Access Compliance Report

Public Rights-of-Way

(Curb Ramps)

Intersection ID: 29165	Main Street: BOXELDER_LN	Cross Street: PURPLE_BLOOM_LN	Location: S
ADA ID: B147258D2576	Ramp Type: PerpDiag	Initial Pass/Fail: Fail	Overall Compliance: No
Severity Score: 21.25			
Codes/Mitigation Info/Possible Solution		Field Measurements/Component Compliance

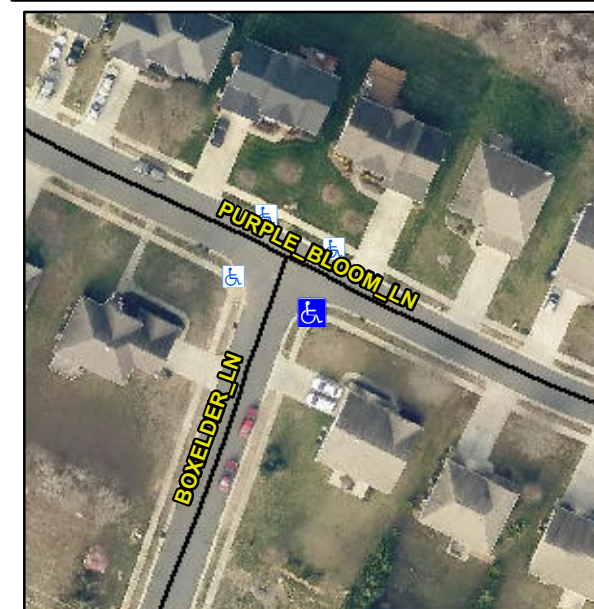
Not Found, R304.5.1, R304.5.3

Compliance	Description	Data	Compliance	Description	Data
N/A	Ramp Length (in)	47.5	Yes	Ramp Slope (%)	6.6
No	Ramp Width (in)	46.0	No	Ramp XSlope (%)	5.8
N/A	Flare Type LT	N/A	N/A	Flare Type RT	N/A
N/A	Flare Slope LT (%)	N/A	N/A	Flare Slope RT (%)	N/A
N/A	Flare Traversable LT?	N/A	N/A	Flare Traversable RT?	N/A
N/A	Landing Length (in)	N/A	N/A	DWS Provided?	N/A
N/A	Landing Width (in)	N/A	N/A	DWS Contrast?	N/A
N/A	Landing Slope (%)	N/A	N/A	DWS Length (in)	N/A
N/A	Landing X Slope (%)	N/A	N/A	DWS Full Width?	N/A
N/A	Landing Curb? (Y/N)	N/A	N/A	DWS Offset (in)	N/A
N/A	Shared Landing?	N/A			
N/A	Gutter Ponding?	N/A	N/A	Gutter Slope (%)	N/A
N/A	Gutter Lip Ht (in)	N/A	N/A	Gutter X Slope (%)	N/A
N/A	Painted X Walk1?	No	N/A	Painted X Walk2?	No
	X Walk 1 Direction	To NE		X Walk 2 Direction	To NW
N/A	X Walk 1 Width (in)	N/A	N/A	X Walk 2 Width (in)	N/A
	X Walk 1 Slope (%)	0.5		X Walk 2 Slope (%)	4.3
	X Walk 1 X Slope (%)	3.0		X Walk 2 X Slope (%)	2.3

Remove & Replace Curb Ramp With Two New Directional Ramps or Equivalent.
